**VIRGINIA ELECTRIC AND POWER COMPANY**  
**SURRY POWER STATION UNITS 1 AND 2**  
**MAIN STEAM FLOW TRANSMITTER ACCURACY**

ATTACHMENT 1  
ADDITIONAL INFORMATION  
MAIN STEAM FLOW TRANSMITTERS

Figure 1  
Surry Steam Flow Measurement Uncertainty  
Signal with Uncertainty as a Function of Flow

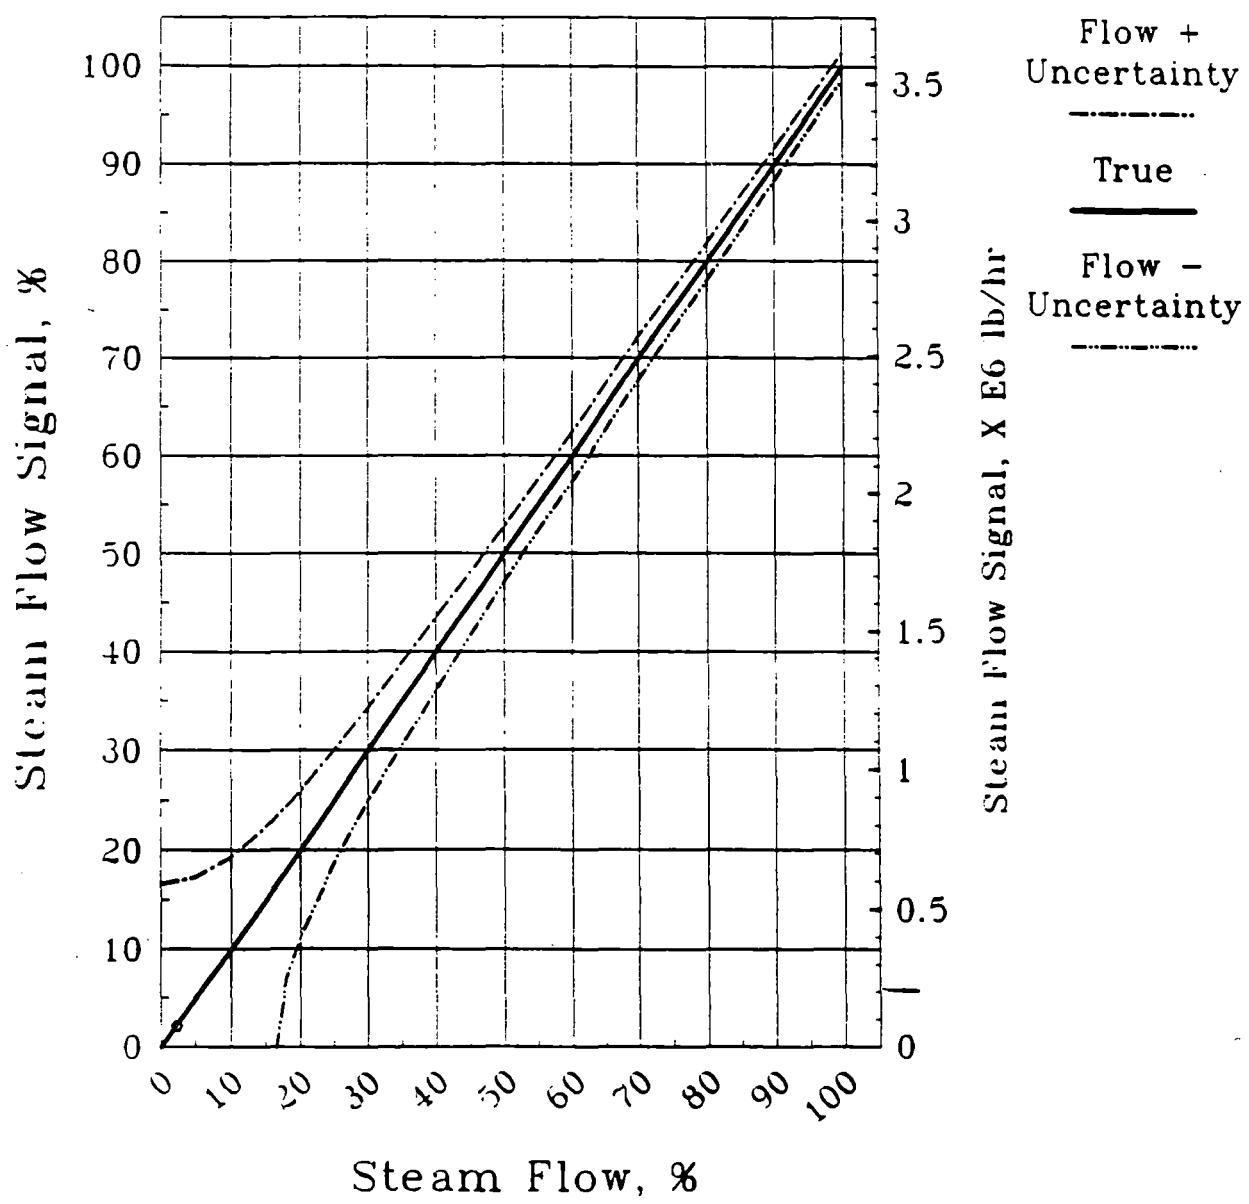
The North Anna verification of steam flow indication is required at or before 5% power while the Surry verification is required at or before 23% power. Please explain this difference.

The Surry steam flow indication verification at 23% power does not imply that the accuracy of steam flow indication is undesirable below 23% power. Figure 1 illustrates that a single channel has at least a 50% probability of indicating some steam flow (ie., 100,000 lb/hr or more) even at very low steam flow rates such as 100,000 lb/hr steam flow. At 16% steam flow, there is a much higher probability for indicating some steam flow, approaching 70% to 95% for a single channel. These steam flow uncertainties are combined for the comparison, yielding a difference criteria with the same 70% to 95% probability for a correct decision. If a higher rate of incorrect decisions or a lower sensitivity (ie., higher difference value) were chosen, the power level for the successful verification could be reduced.
